DEVIATION REQUEST AND DECISION FORM

Project Name : CLOVERLEAF FILING NO. 2
Schedule No.(s) : 7124202236, 7124202239, 7123103007, 7124202238
Legal Description : SEE ATTACHED -- Exhibit B

A deviation from the standards of or in Section **ECM Ssection 3.3.1.J.2** of the Engineering Criteria Manual (ECM) is requested.

DP01 PROFILE (1)
STA 1+00.00 TO 5+50.00

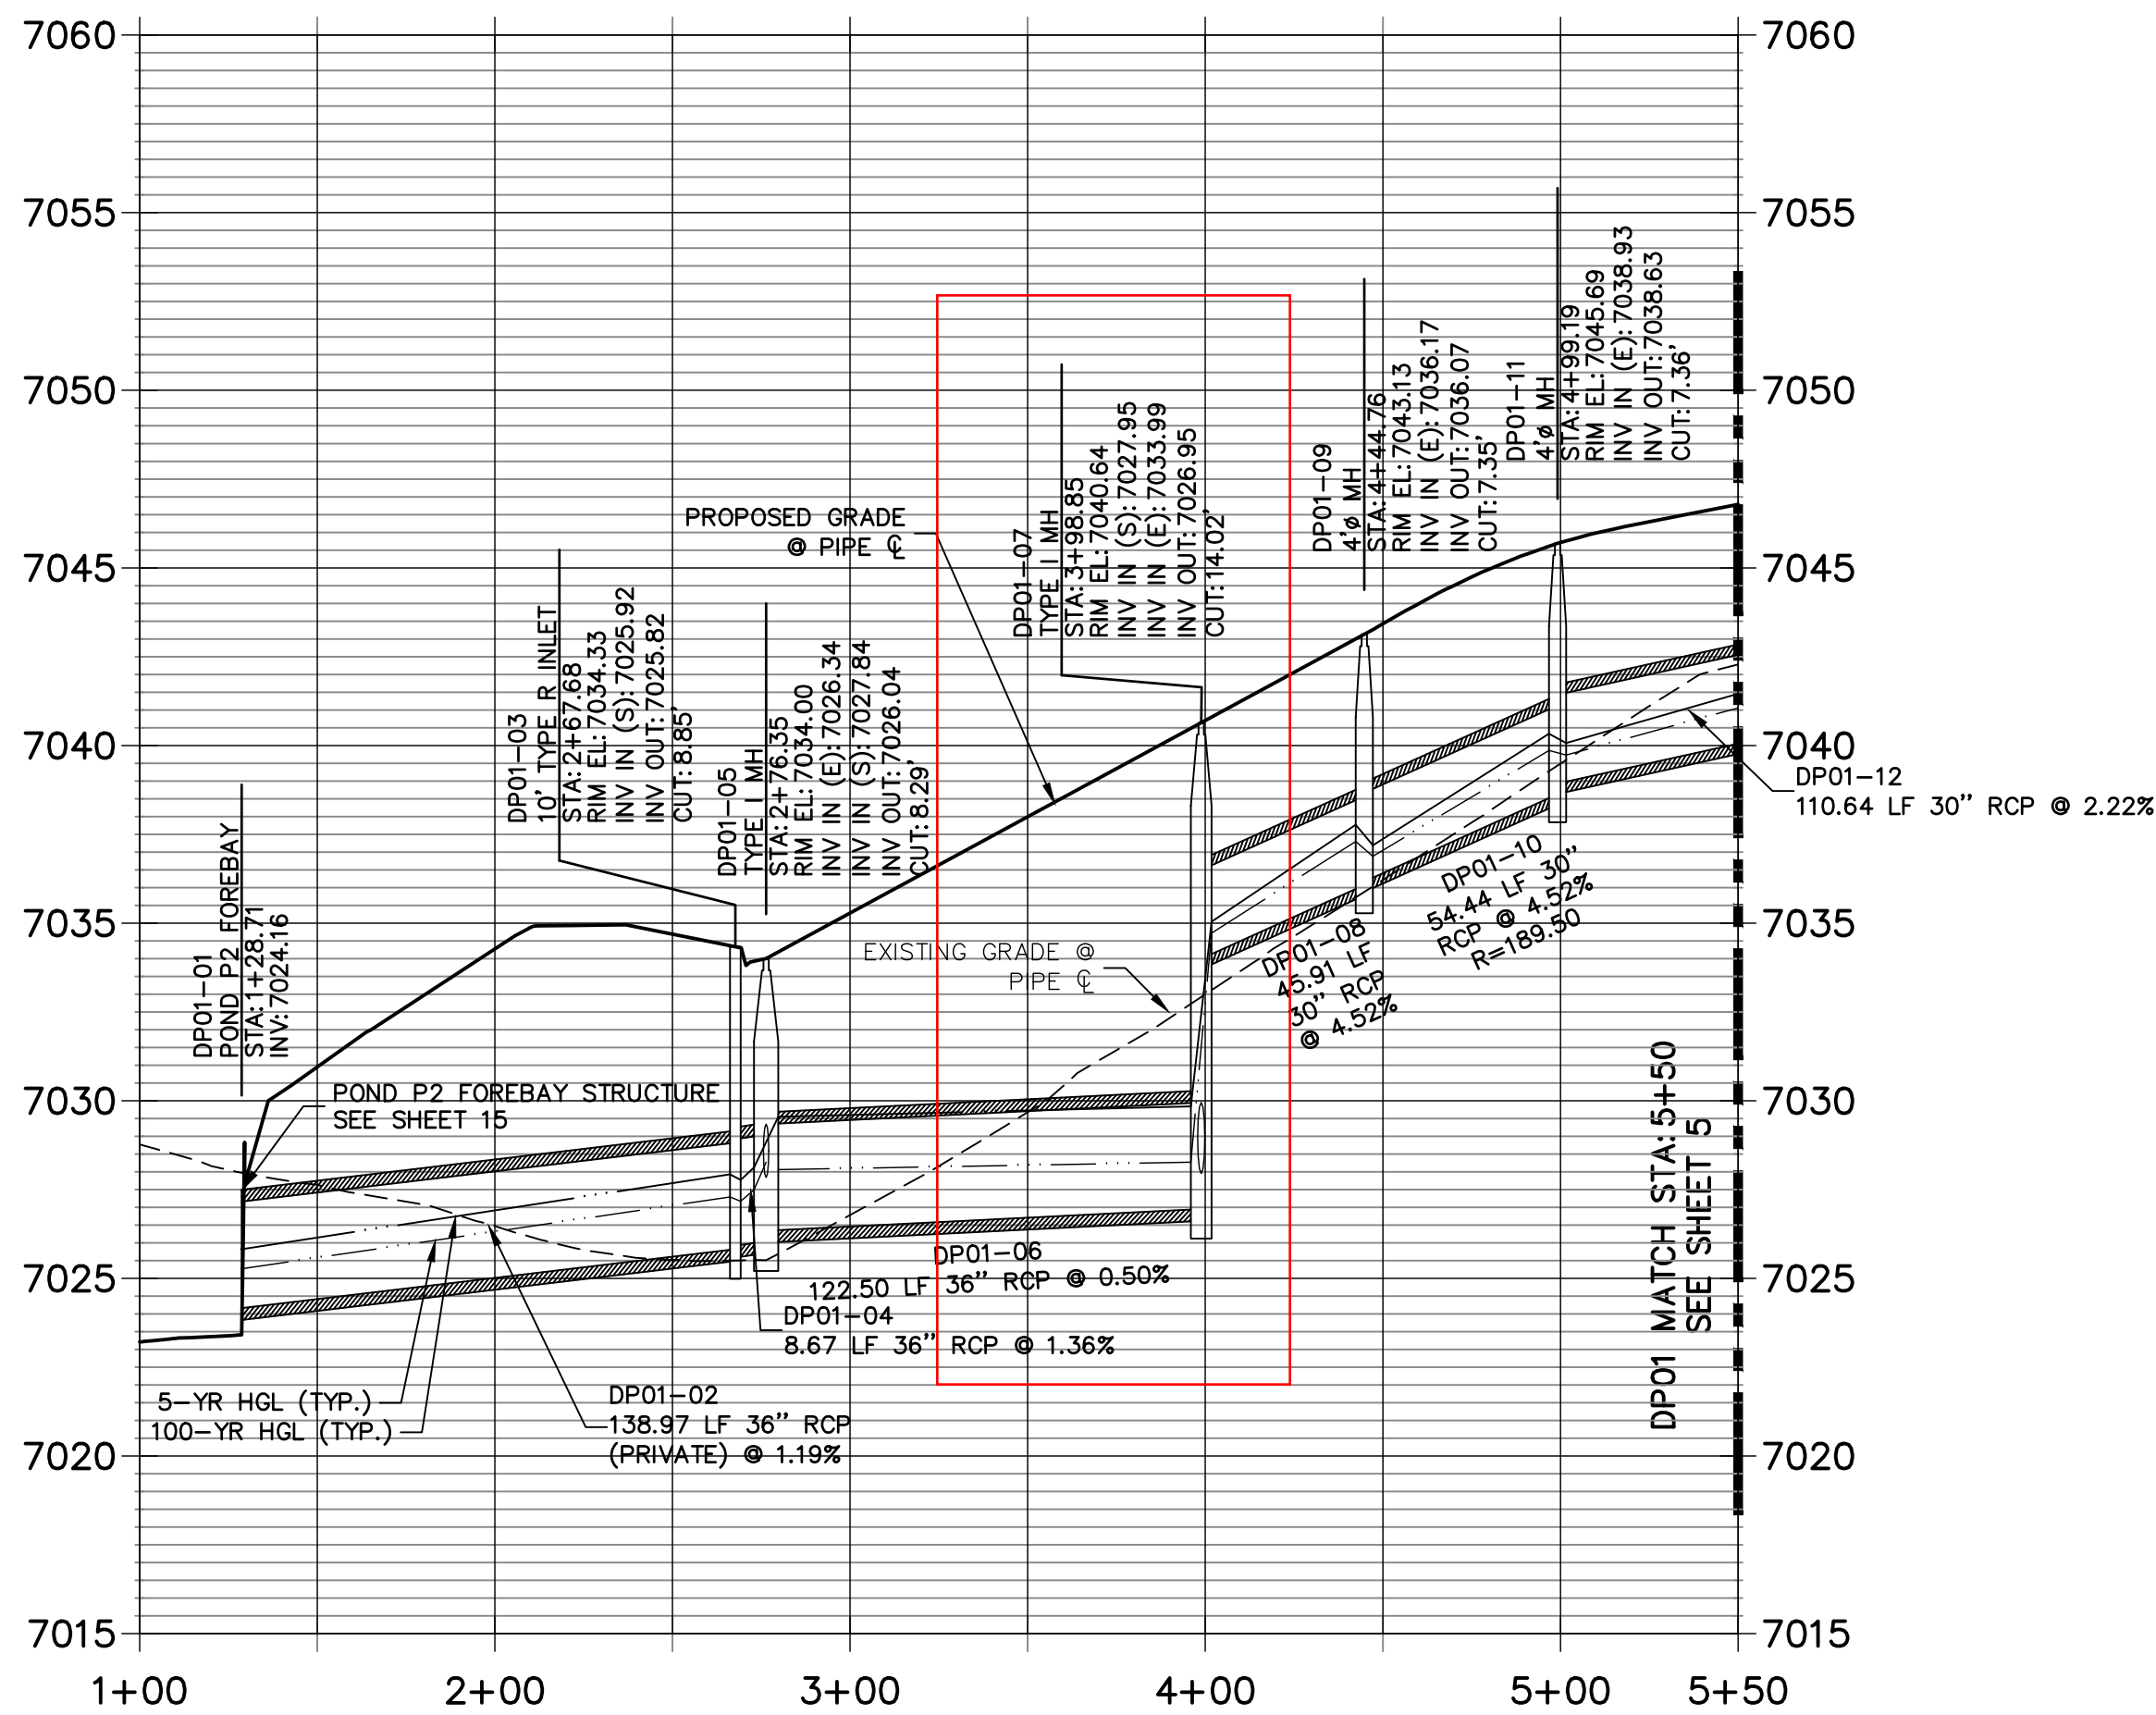
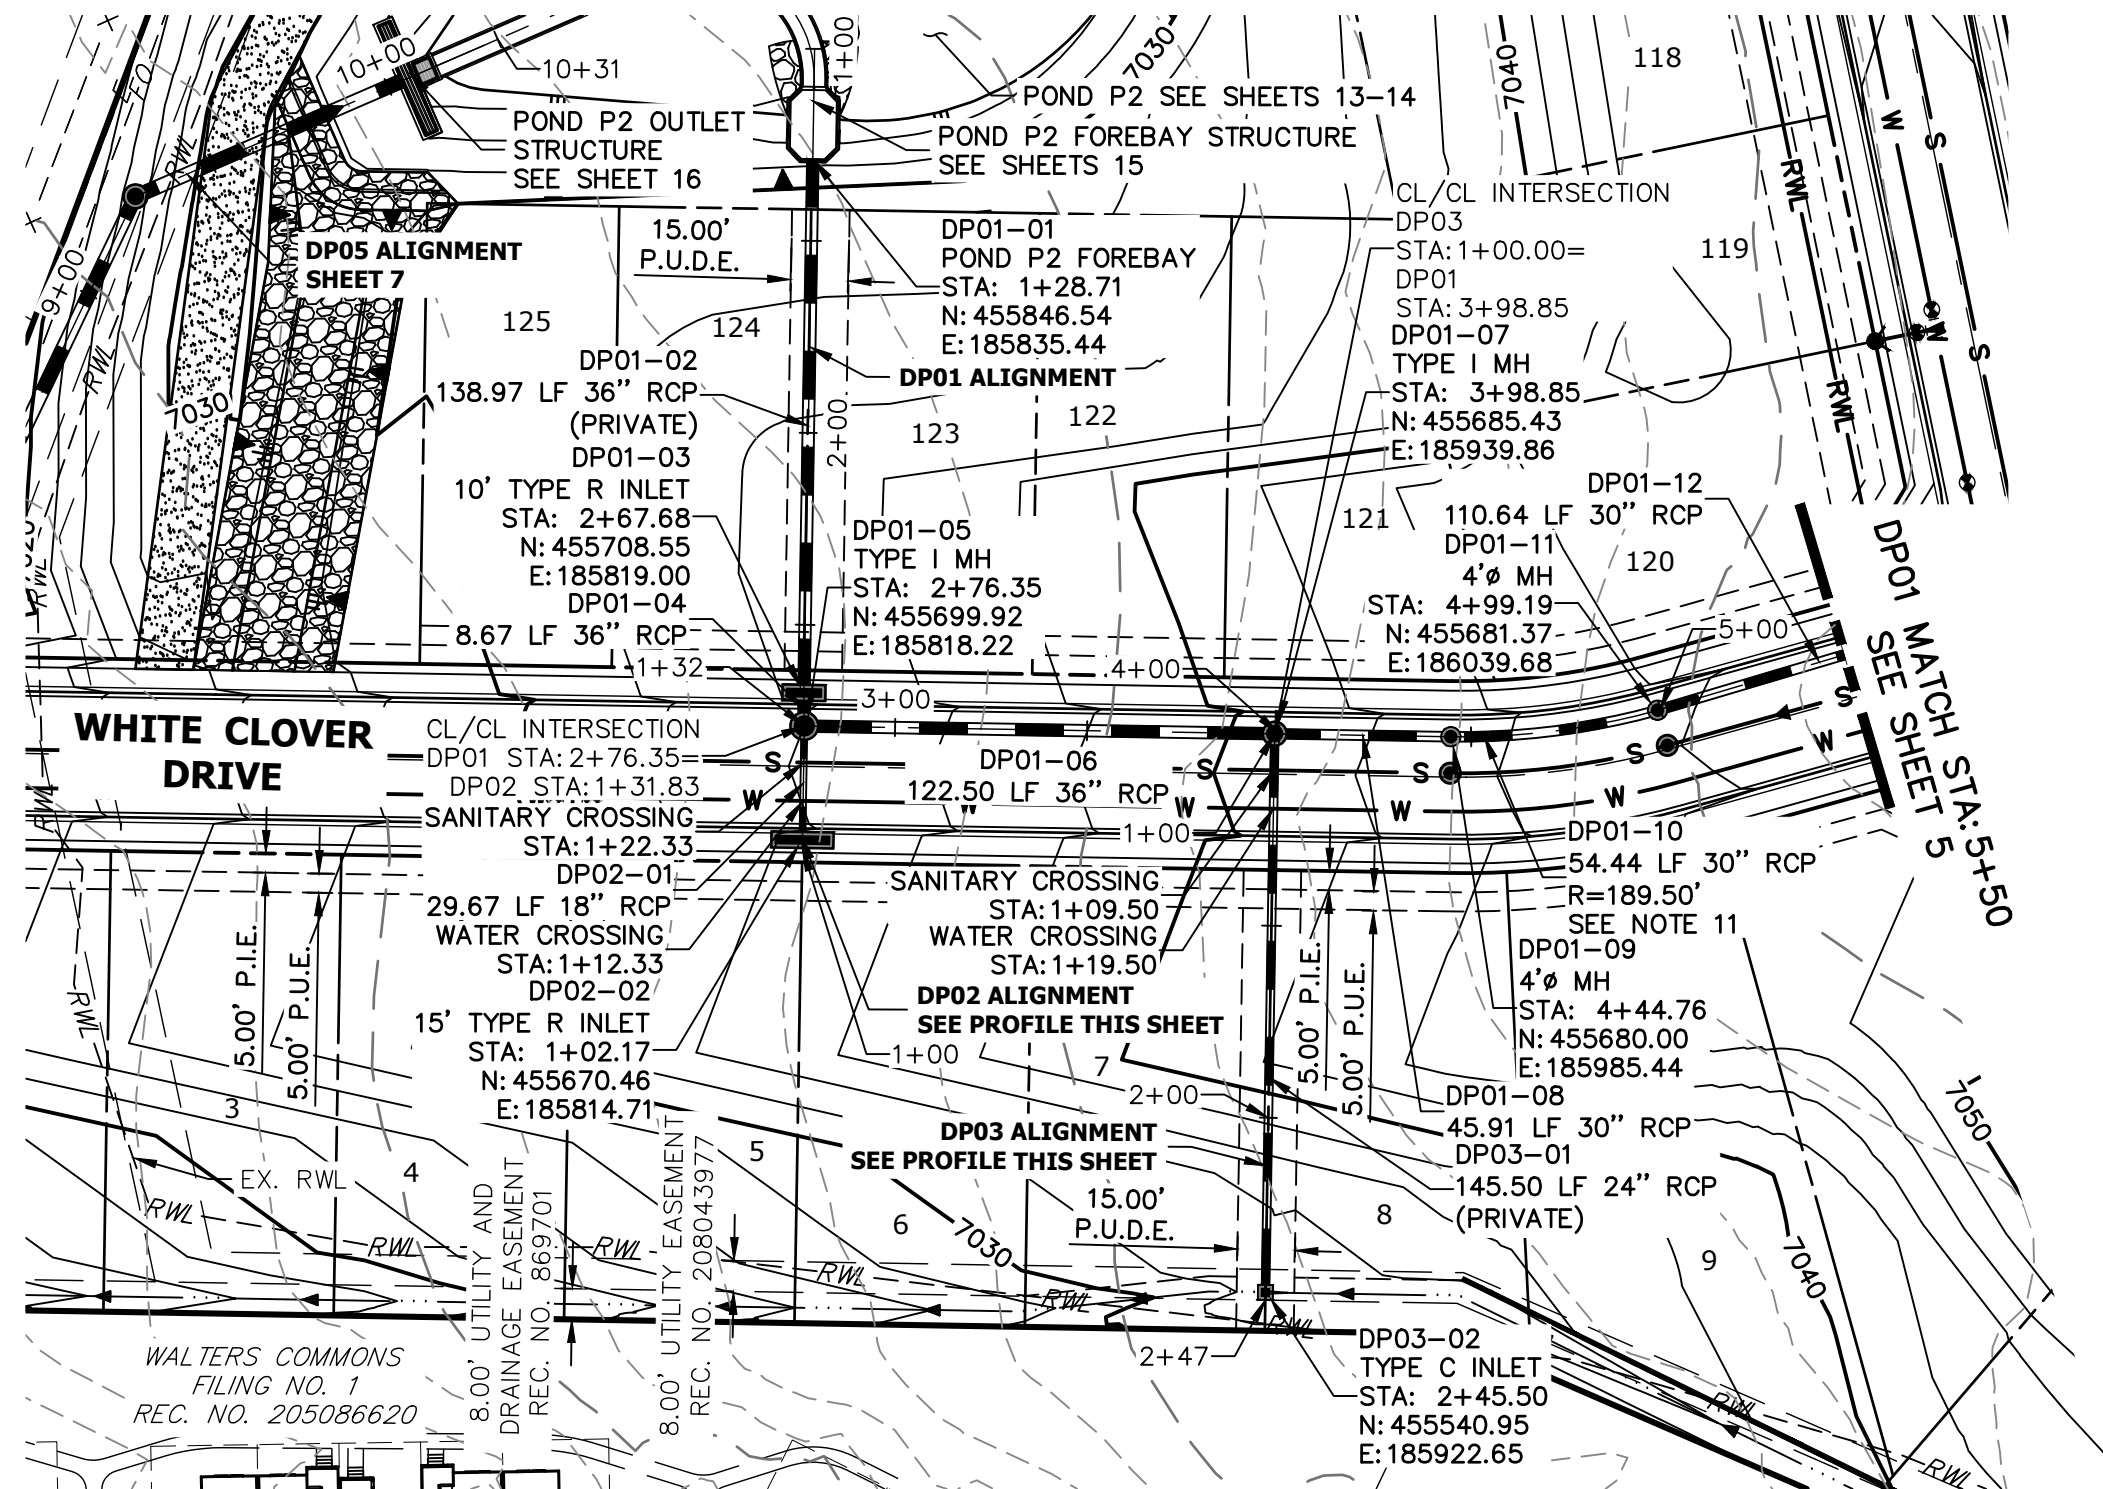
MH-DP01- 07 (6.0 ft. drop): This drop manhole is necessary collect the flows from rear yard swale along walk out lots 8-18 while allowing the White Clover Drive storm system to be at normal depths and not conflict with the sanitary sewer system.

OUTFALL WINGWALL AND
SWALE SECTION A-A

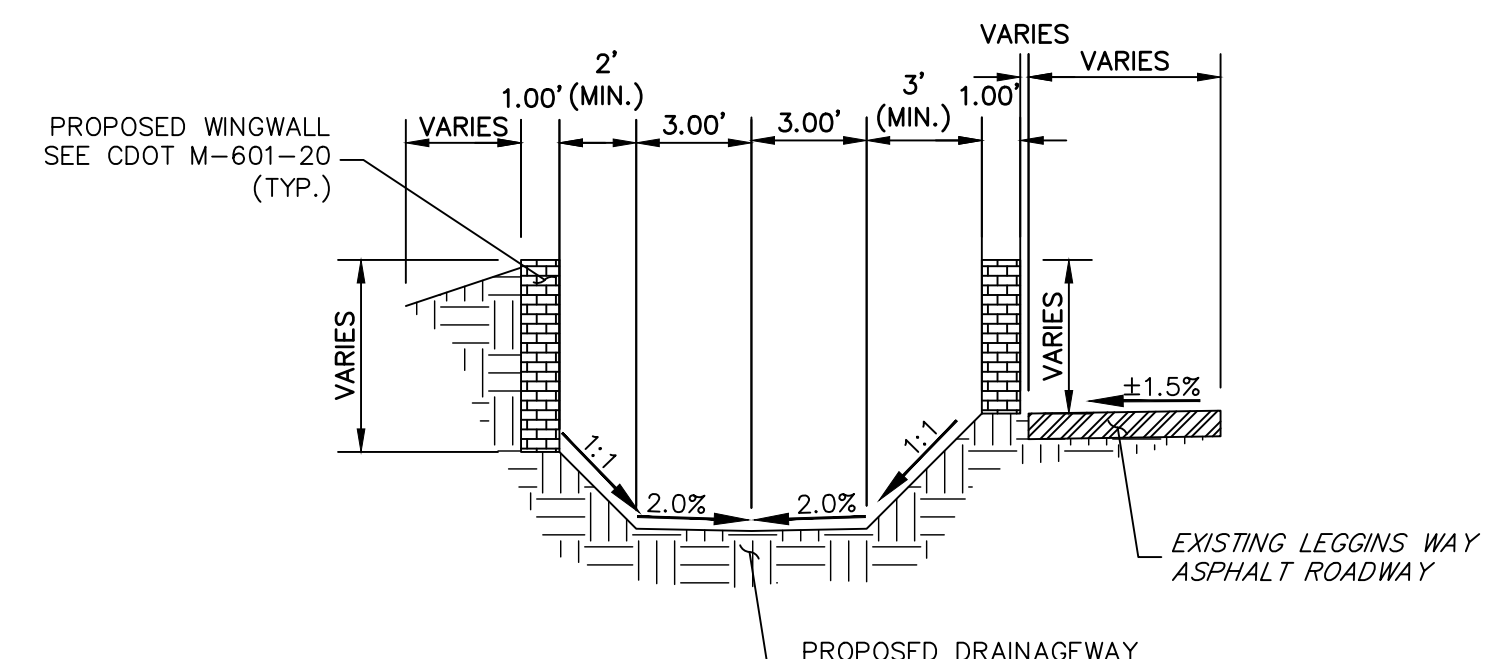
MH-DP05-15 (5.8 ft. drop) and MH-DP05-13 (2.8 ft. drop): Pond 2 outfall to Bowstring. Slopes and associated velocities within the storm sewer system are optimized to be just below the allowable maximum velocity for the Q100 event.
